### LEAKAGE FROM UNDERNEATH THE YOT TYPE TOP LOADED WASHING MACHINE.

#### DESCRIPTION:

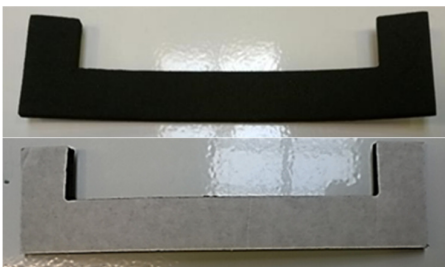
When the lid is opened, after the end of washing cycle, residual water may drip from lid's innerliner into the gap between lid and top part (Photo 1). Then it flows to the water gutter under control panel (Photo 2). After several consequent cycles it may cause water accumulation, leading to overflow (Picture 3) through hole to the bottom of appliance.

The gap between top part and water distributor has to be sealed.

Order sealing gasket.

Remove the control panel (see service manual).
